Inola Industrial Rail Facility
Addendum No. 5
October 25, 2022

FES #: 40743	DOCUMENT TYPE: EXHIBIT - ADDENDUM 5"
DRAWN BY: TAR	UNION PACIFIC RAILROAD For Use and Agreement City of Tulsa - Rogers County Port Authority
CHECKED BY: JLM	LOCATION & DESCRIPTION: Black Fox, Ok - Wagoner Sub MP 594.76 to MP 595.18 Trackage to Serve: Tulsa Ports
DATE: 10/24/22	SHEET TITLE: Proposed Site Access Route
SHEET NUMBER: 01

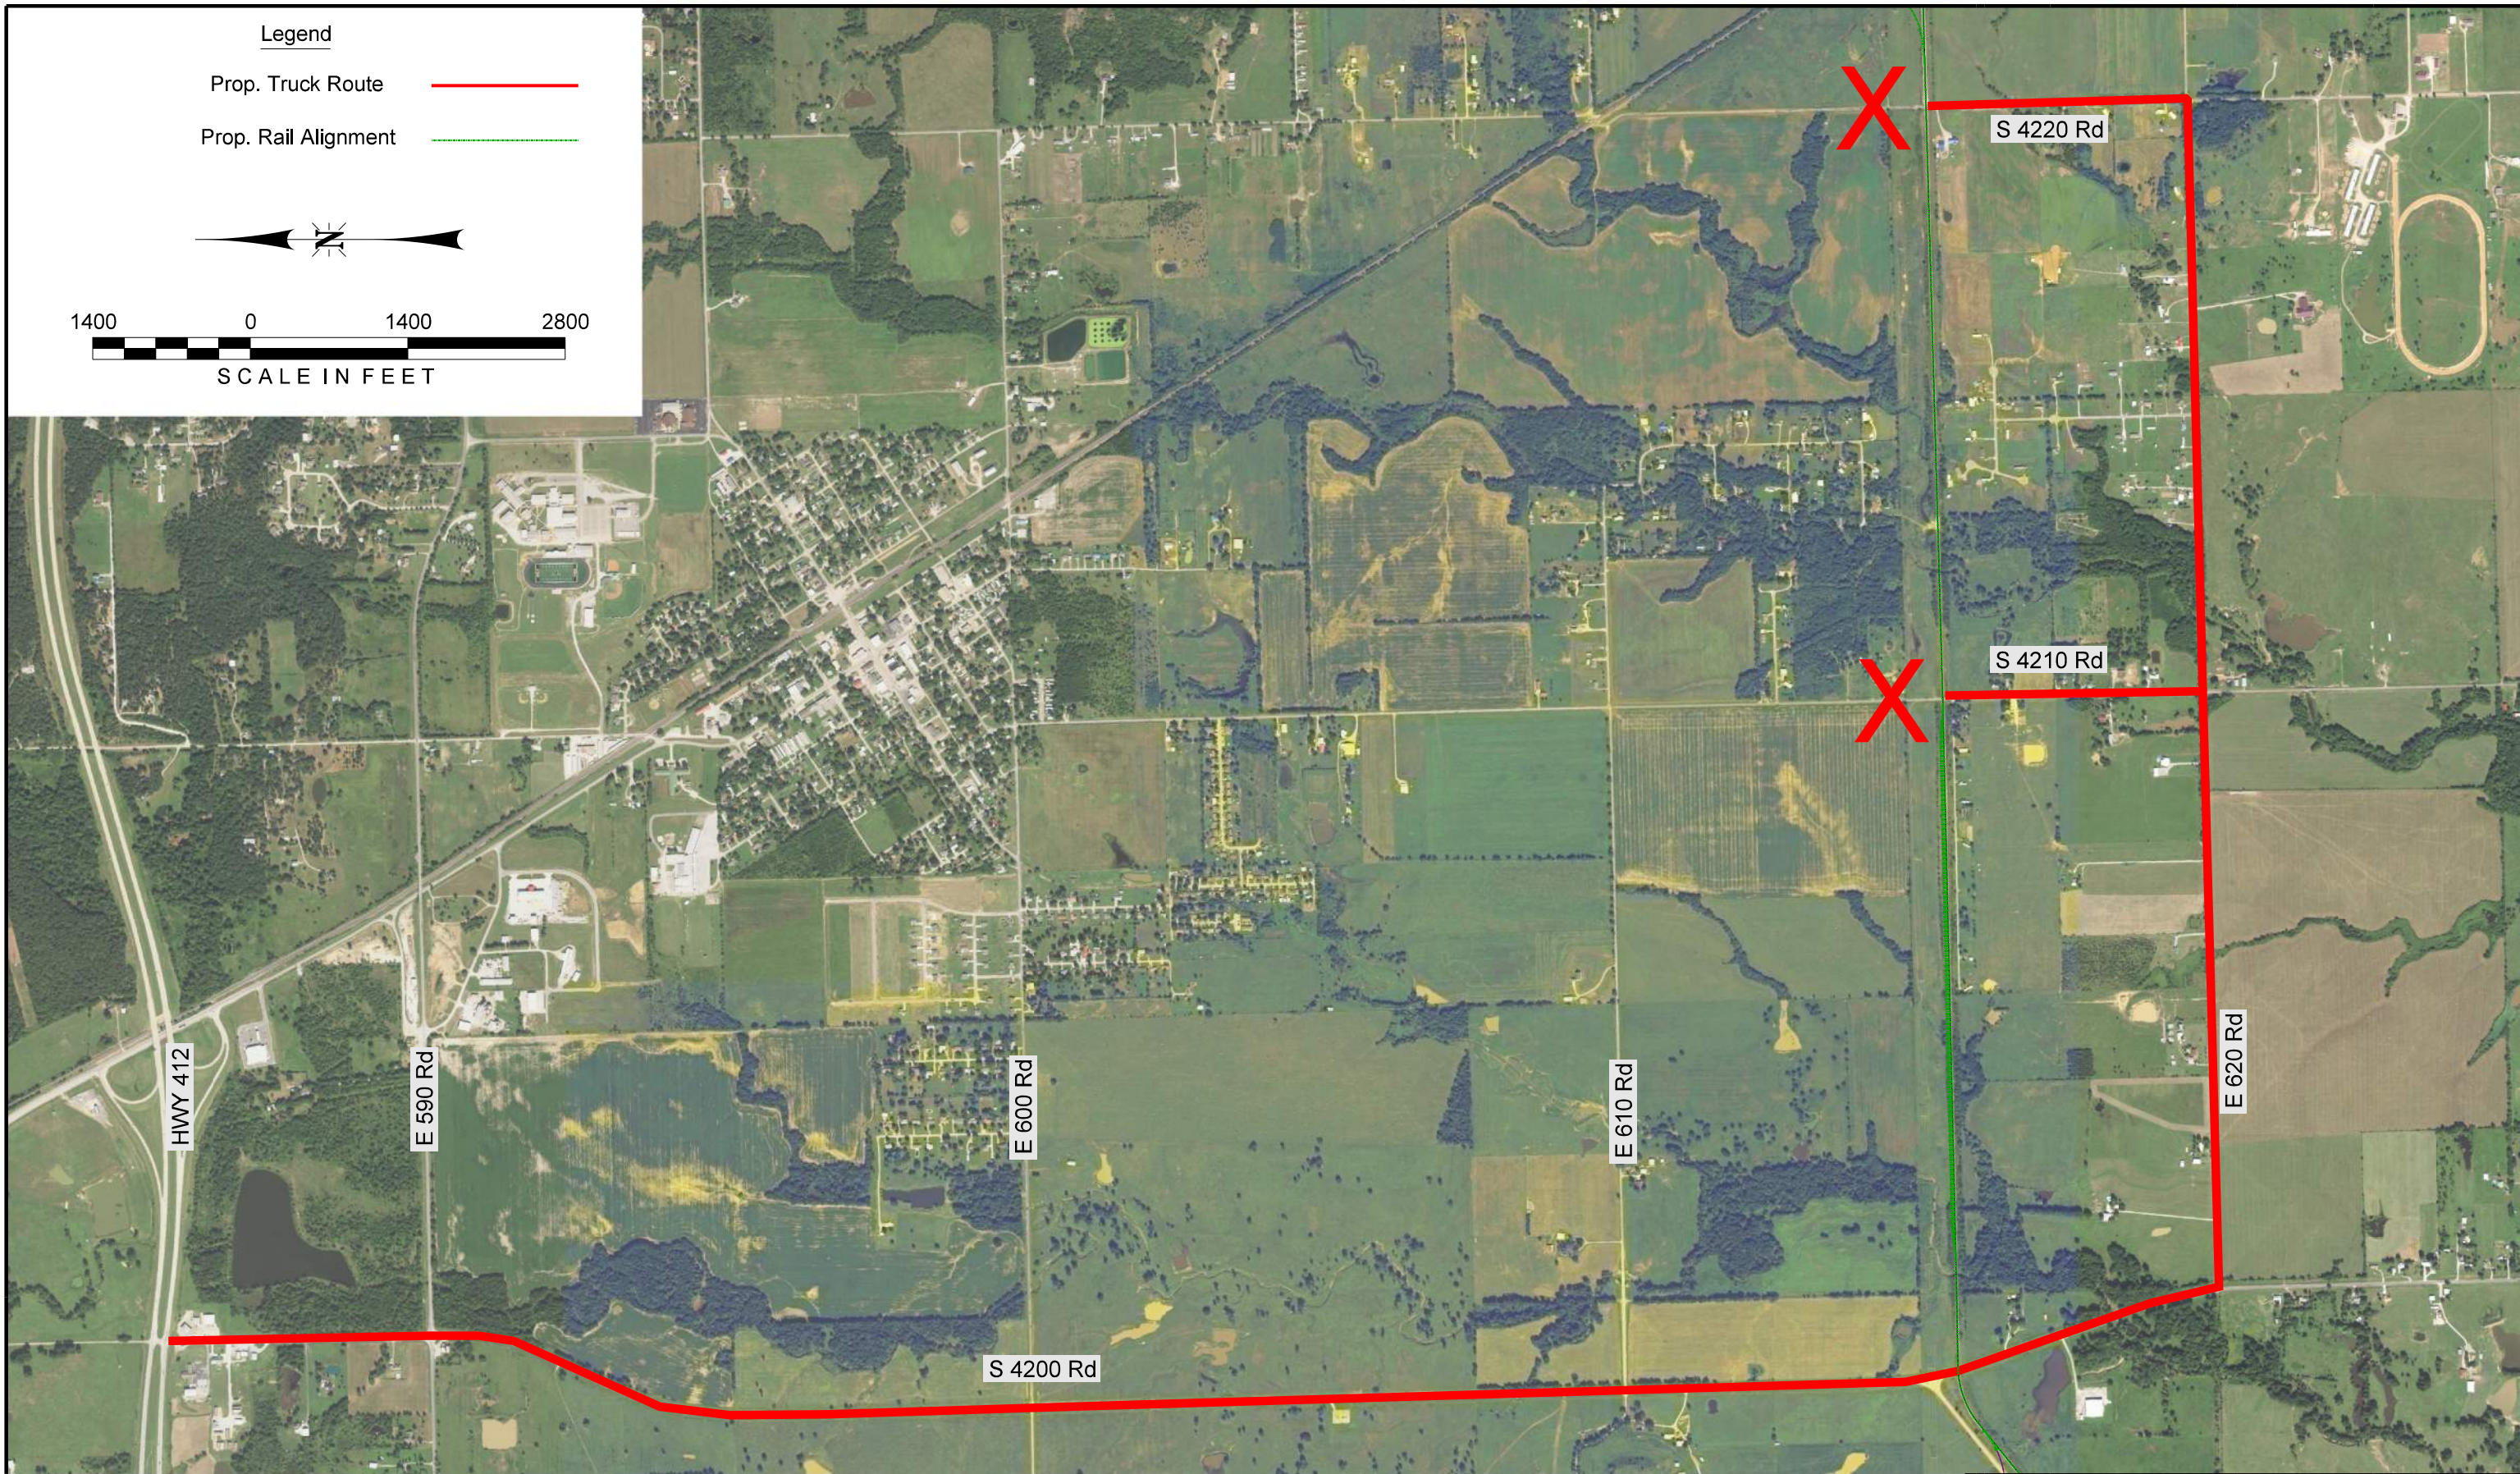
8. What roads can contractors use? **See attached exhibit. Contractor shall be responsible for all tickets/fines received for use of prohibited roads.**
